April 6, 2011

**Re: Indian Mound Park / Franklin County
Construction Storm Water Permit 4GC03322*AG**

This letter is written in follow-up to a construction storm water inspection that I conducted at Indian Mound Park, located at 3901 Parsons Avenue, Columbus, Ohio, on March 31, 2011. The purpose of the inspection was to evaluate compliance with the General Storm Water Permit Associated with Construction Activities. During the inspection, I noted the following issue associated with construction activities at this site:

**Indian Mound Park
Stabilize barren areas
Scioto River Watershed
March 31, 2011
Photo by: Greg Sanders**

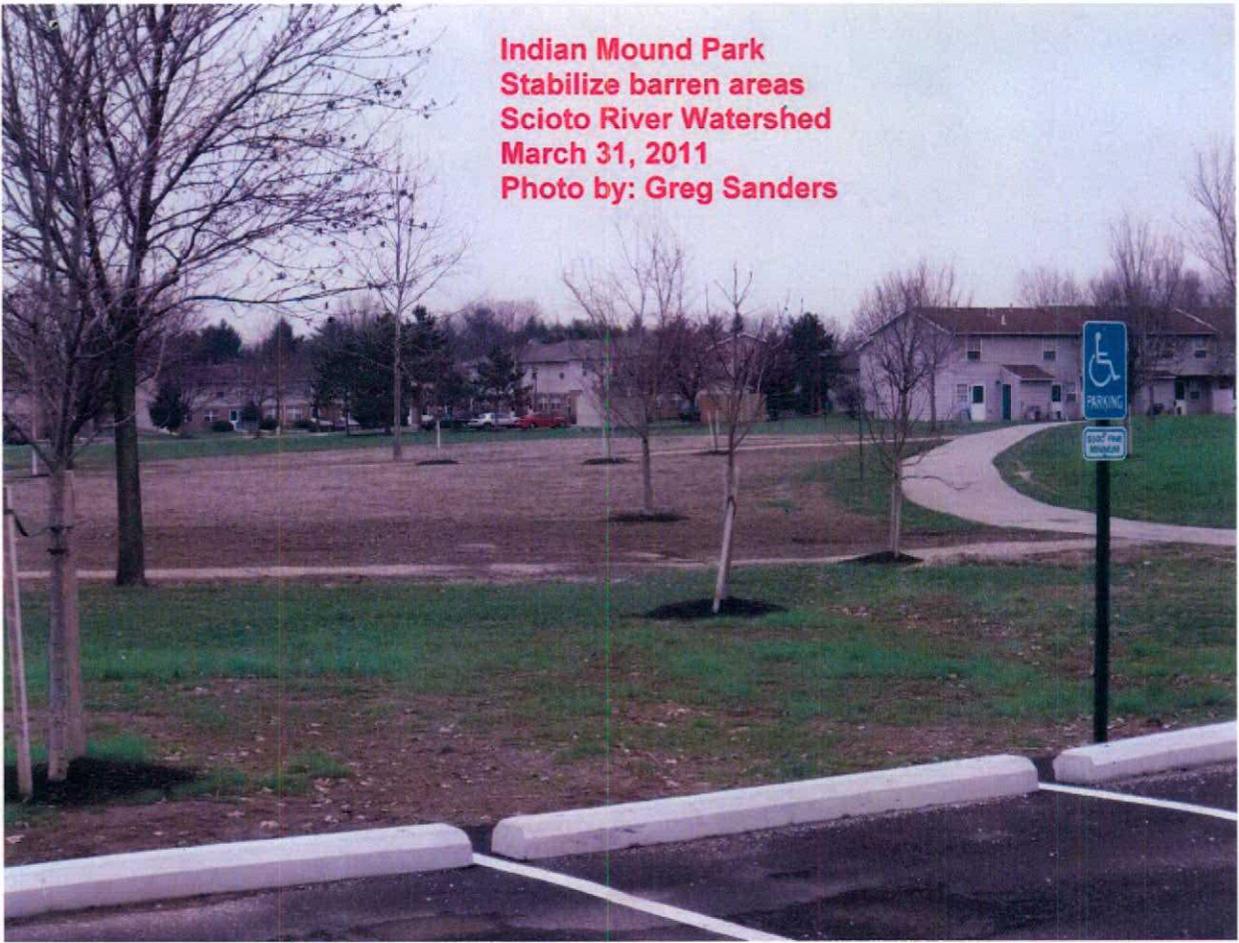
- Please be aware the General Permit states that all barren areas which remain idle in excess of 21 days must be protected from erosion within 7 days of the last earth disturbing activities. In addition, erosion protection must be implemented for all areas of final grade within 7 days. A small portion of the site was barren. Please stabilize the site. Please see attached pictures.

**Indian Mound Park
Will need to re-seed
Scioto River Watershed
March 31, 2011
Photo by: Greg Sanders**
